Technical Service Bulletin

43 Air suspension system fault - DTC C118D01 Compressor for level control electrical error

43 24 88 2073034/4 May 7, 2024. Supersedes Technical Service Bulletin Group 43 number 24-87 dated April 11, 2024 for reasons listed below.

Model(s)	Year	VIN Range	Vehicle-Specific Equipment
Q5, Q5 e quattro, Q5 Sportback, SQ5, and SQ5 Sportback	2023 - 2024	All	Air suspension system

Figure 1. Verify that the compressor electronics is part number 4M0.907.778.A.

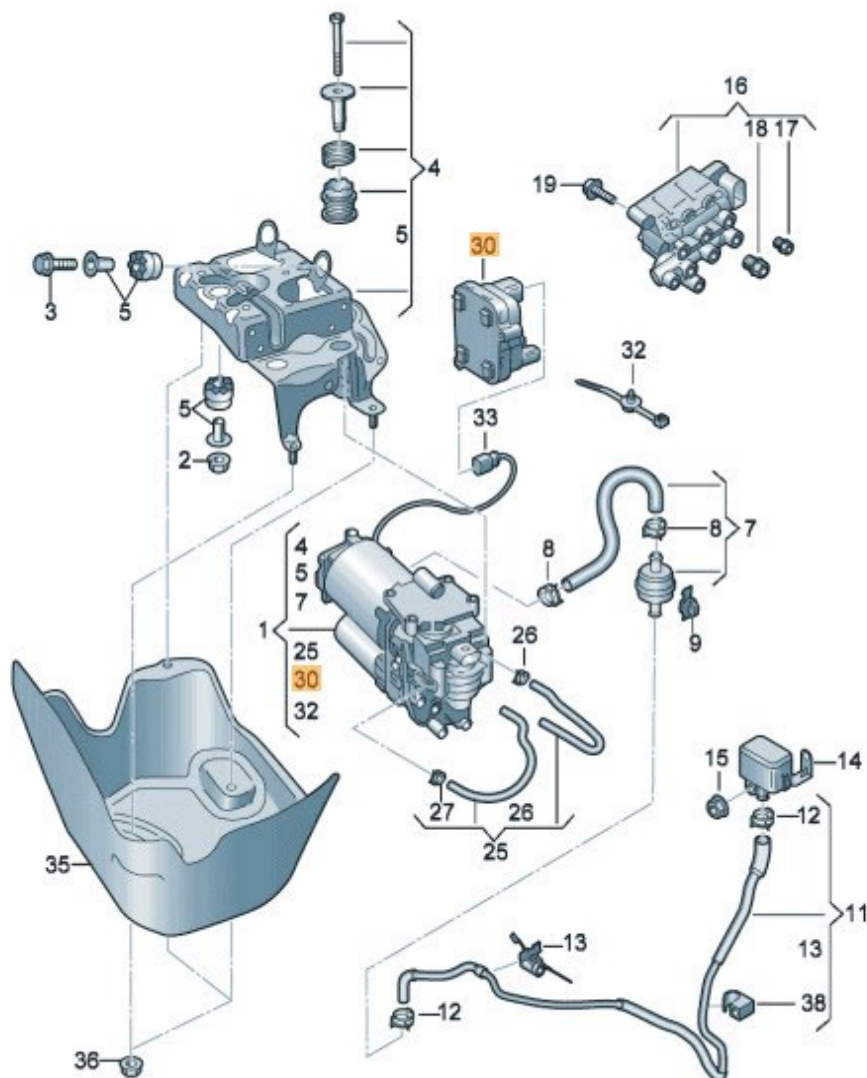
The described procedure only applies if compressor electronics with part number index A are fitted in the vehicle (affected part number 4M0.907.778.A) (Figure 1, number 30).

- If the DTC is **passive/intermittent**, delete the DTC.
- If the DTC is logged as **active/static** and remains active/static after the ignition is switched off and then on again, replace the control unit for compressor electronics J1135 (**not the air compressor**).
- Please use part number **4M0.907.778 (Without index A)**.
